To: Facilities and Technology Committee Meeting on
Date: *10/30/19*
From: Bond Department
Date: *10/23/19*
Re: **Garfield Modular Classroom Building Change Order #3**
Project Description: **18-29**

CO #: 3
Date: November 6, 2019
Contract Date: May 14, 2019
DSA Application #: 01-117762
DSA File #: 01-35

PCO# 11 – Added cost to install a new water valve and install the irrigation line to the field.
PCO# 12 – Added cost to install a new water line and electrical wiring to the Davis St Daycare.
PCO# 13 – Credit for reducing the size of the bioswale.
PCO# 14 – Added cost to install additional interior doors.
PCO# 15 – Added cost to demo, cap and backfill an existing storm drain line that was not shown on the construction documents.
PCO# 16 – Added cost to install a storm drain line to capture the water from the rain gutters.
PCO# 17 – Added cost to install FRP panels as backsplashes for the sinks in each classroom.
PCO# 18 – Added cost to repair the existing sewer line.
PCO# 19 – Added cost to install an additional hose bid by the mechanical units and install rough-ins for future security cameras.
PCO# 20 – Added cost to furnish and install sand slurry over the storm drain pipe that w

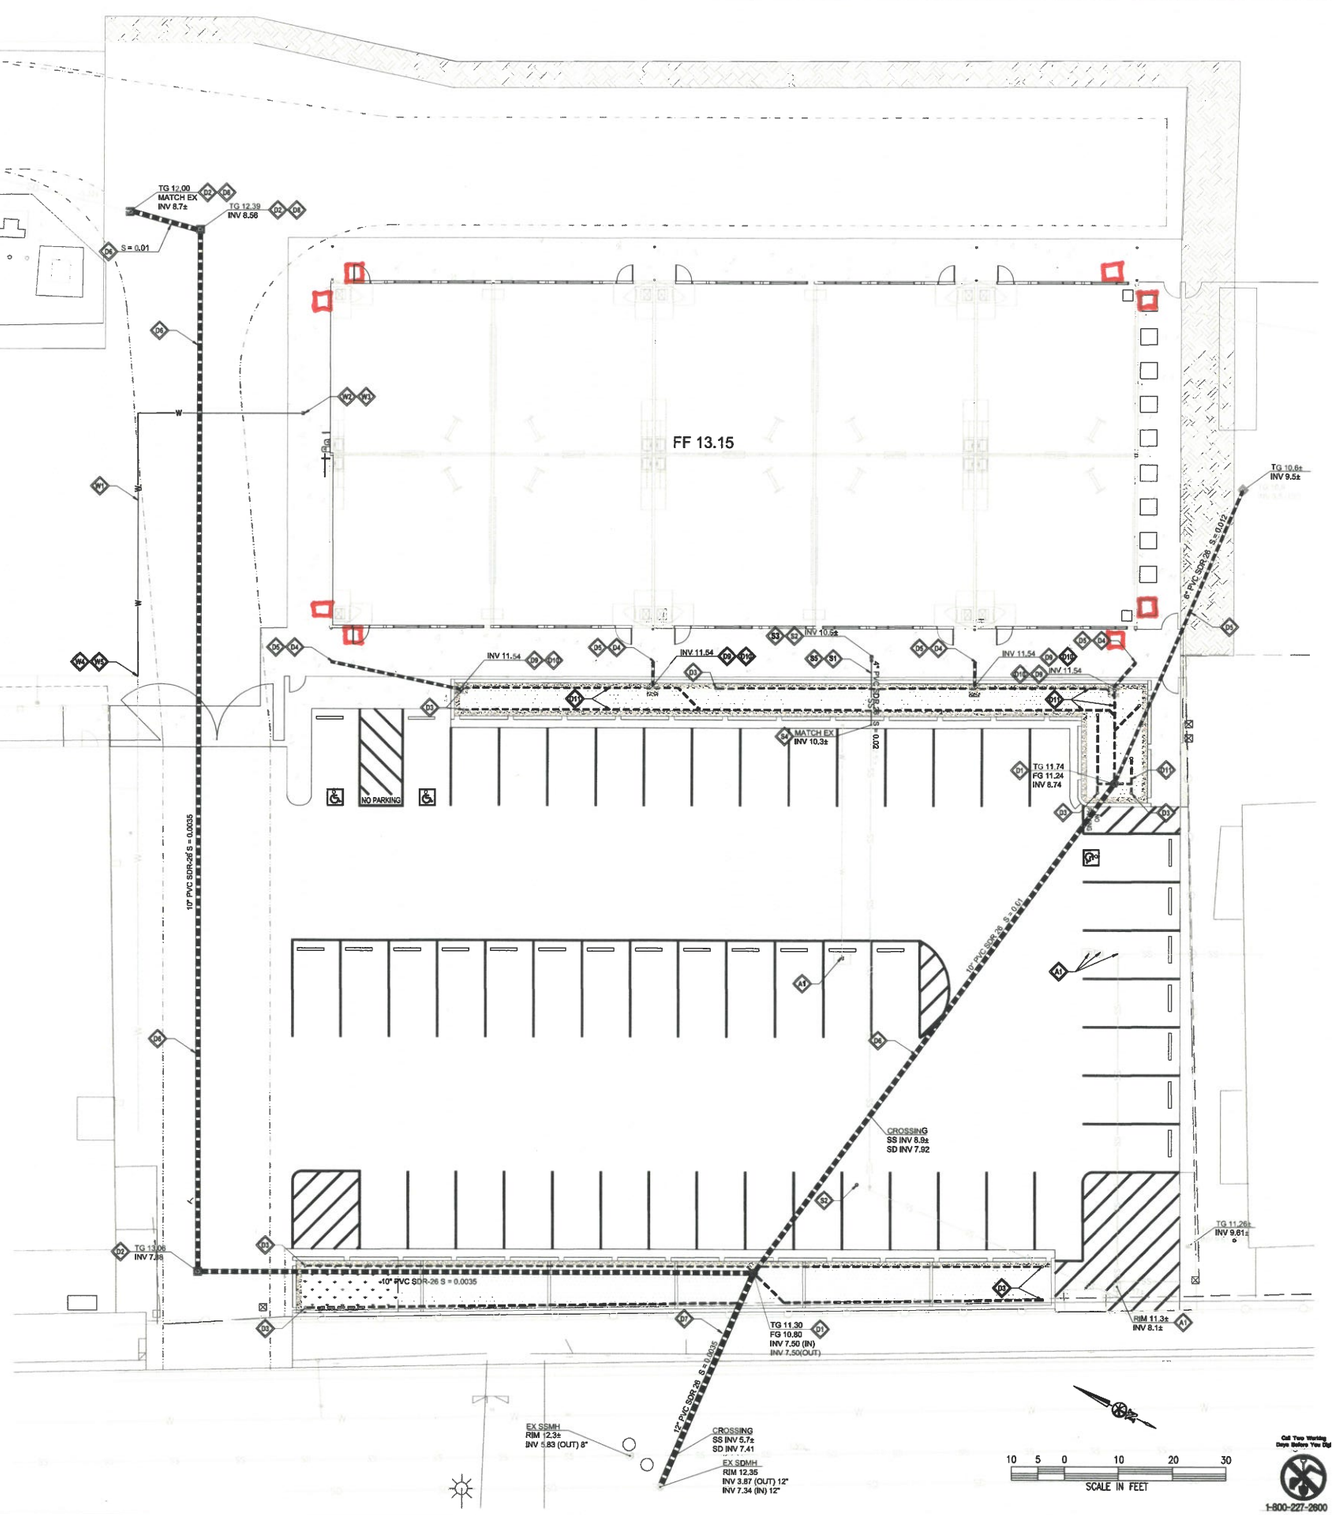
Please see attached camera locations.
We are asking for a Four Square box at each location with a Cat 6 cable inside each one with a run to the IDF.
Please install the boxes 1' below the roof and 1' inside from the corner.

At Wilson you there is one location where the District wants the camera installed high on the building, the attachment shows which one.
